IN REPLY REFER TO:  
3482  
U-044076  
U-0147570  
(UT-066)

Re: Skyline Mine, Resource Recovery and Protection Plan (R2P2), Minor Modification Request, Federal Coal Leases U-044076 and U-0147570, Lower O'Connor "B" Seam.

MINE 3 LEVEL 2  
CURRENT MINE MAP  
MINOR MODIFICATION - BLOCK "c"

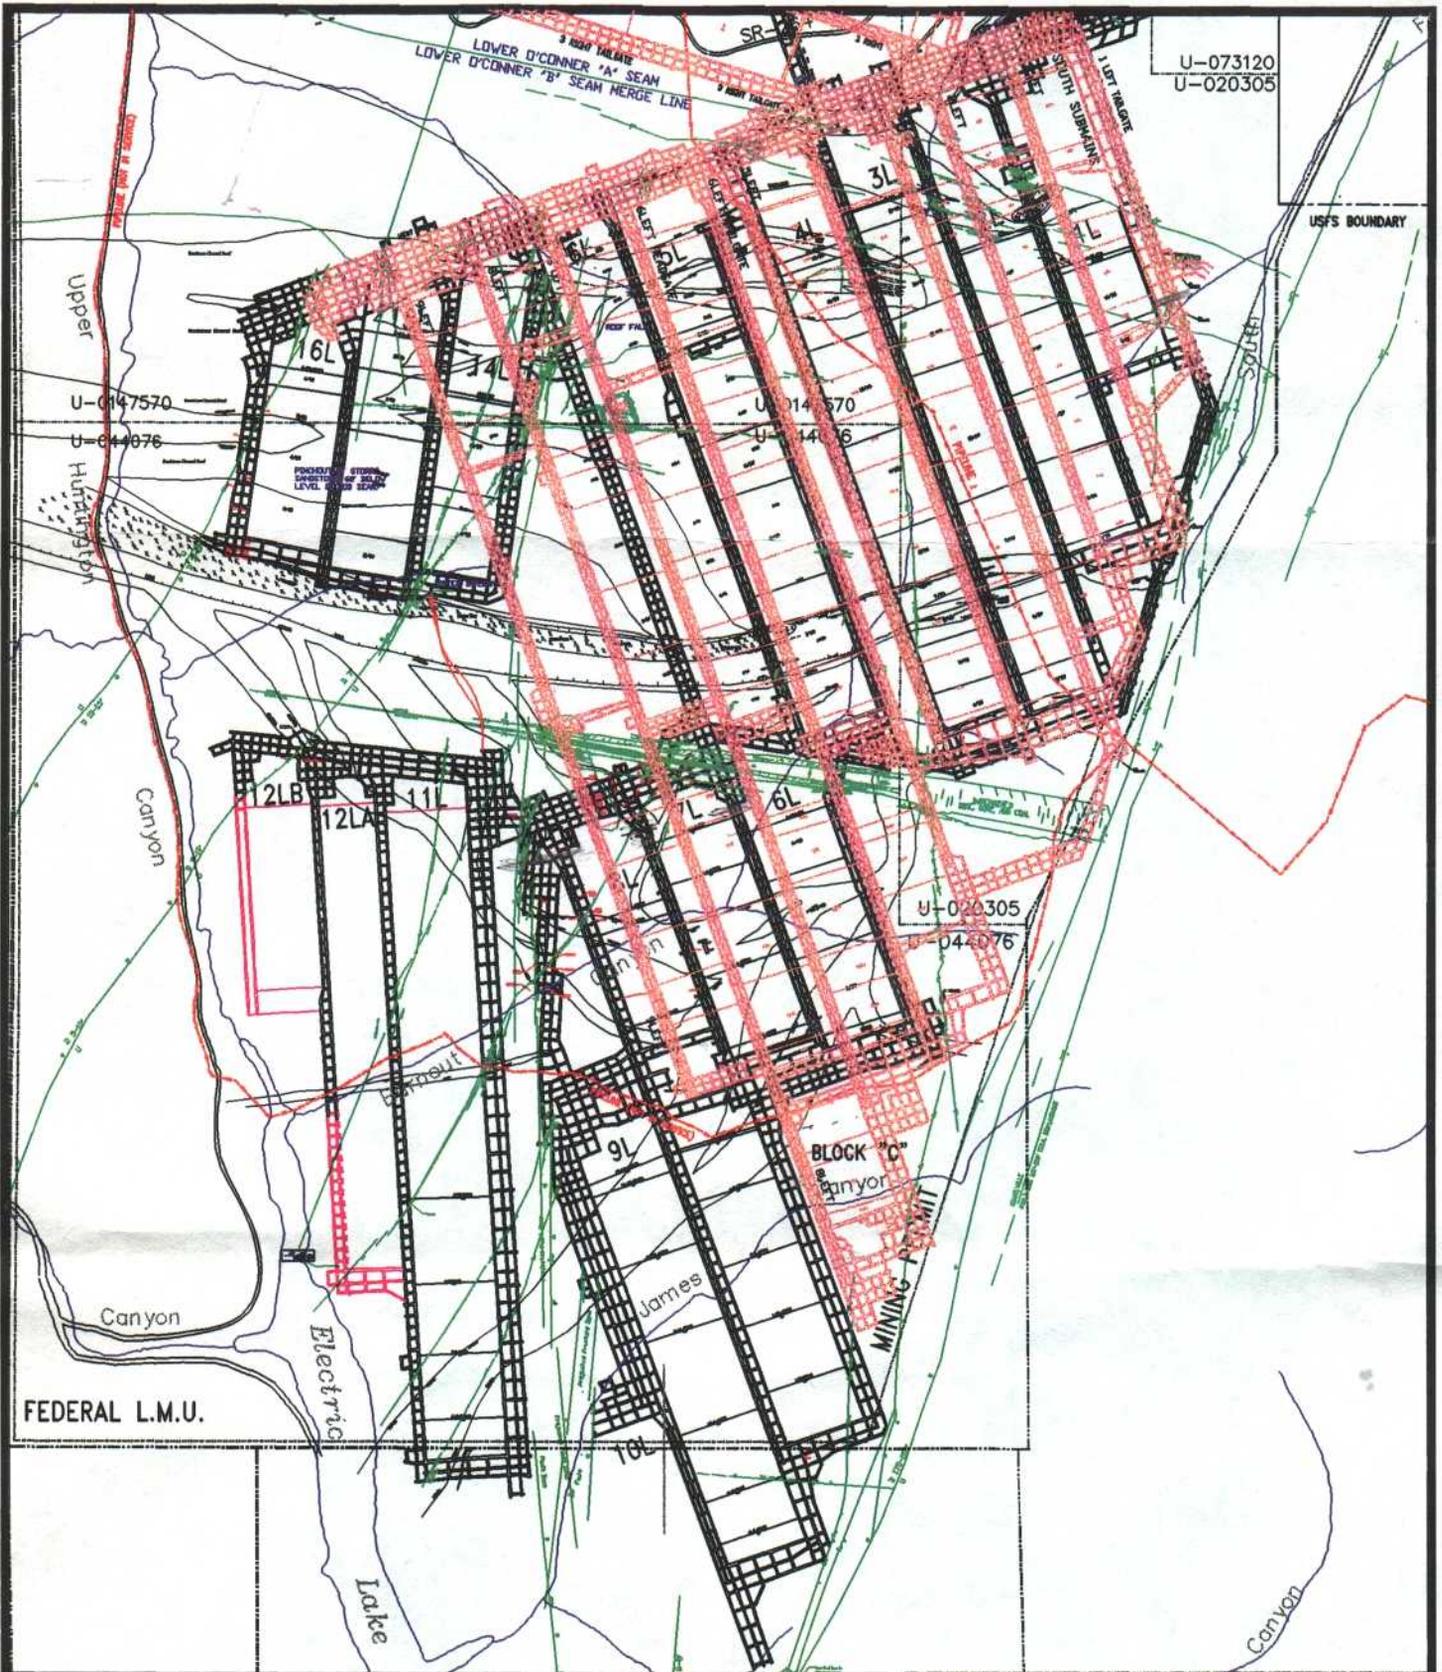
The final request deals with Block "C" (as designated in the R2P2 minor modification approved February 22, 2002). Block "C" is a relatively small block of coal which the BLM had considered mineable; however, it is within the area that will be sealed under this plan. Block "C" underlies a mined cut portion of Level 1 and the interburden between the seams varies from thirty feet to a little over forty feet, a separation which is too small for multiple-seam mining. We understand the BLM interest in recovering this block but the multiple-seam mining which has been done at Skyline Mine has proven that seams this close together are only resources, not reserves. To attempt to mine this block would result in extreme ground control difficulties, making for unsafe conditions and exposures. On December 19, 1996, the BLM approved a "Thin Interburden Modification" to the R2P2 which in essence, removed any requirement for multiple-seam mining when the interburden is less than forty feet. This position applies to Block "C". Further: the same approval took the position that undermining of setup and bleeder entries is not required when the interburden is less than eighty feet. Barrier and abutment loadings are prevalent in Block "C" and

fit the disqualifications found in the 1996 approval. Assuming that Block "C" would have been mined, it would have happened prior to mining the 5 Left panel. At that time, a mainline natural gas pipeline crossed the surface at the north end of the block. The longwall in Mine 1 (now Mine 3 Level 1), above Block "C", was moved around the pipeline barrier and did not undermine it. Had Block "C" been mined in Mine 3 Level 2, the same would have occurred.

A northeast-southwest fault transects part of Block "C" and would have inhibited mining. The fault was identified in Mine 1 mining and adversely affected mining in the Upper O'Connor seam. The set-up room for the 8 Left panel was required to be moved out by its planned location and hazardous mining occurred virtually the entire length of the panel. It would not have been wise or proper to repeat this circumstance in Mine 3 Level 2. It is prudent for Canyon Fuel Company, LLC to also be interested in maximum extraction of the coal reserve. To this end, it has consistently mined all locations that were safe and economic to mine. However, in some cases (such as Block "C"), multiple-seam mining imposes limitations, which prohibit safe, economic mining and Canyon Fuel Company, LLC will not be required to mine such areas.

The affected reserves are located in the lower O'Connor "B" Seam in Federal coal leases U-044076. This will decrease extraction of recoverable coal reserves. The proposed change will delete 330,000 tons from Federal coal lease U-044076. Therefore, 330,000 tons of coal will be deleted from the recoverable reserve base.

- BLM approves the sealing of the 6Left "A" to 10 Left area of Skyline Mine Level 2.
- BLM approves the sealing in by the Dike South Sub-Mains Skyline Mine Level 1.
- BLM approves the request to eliminate the recoverable reserves designated Area "C".

**Conditions of Approval:** BLM will require that prior to lease relinquishment, CFC will delineate and mitigate, if necessary, any and all impacts on the surface and other resources. Prior to relinquishment, summary reports addressing impacts to surface topography; vegetation, hydrology, private improvements and a hazardous waste certification must be submitted to allow for the surface management agency to evaluate impacts from mining. No relinquishment shall be approved until the Authorized Officer determines that the relinquishment will not impair the public interest.
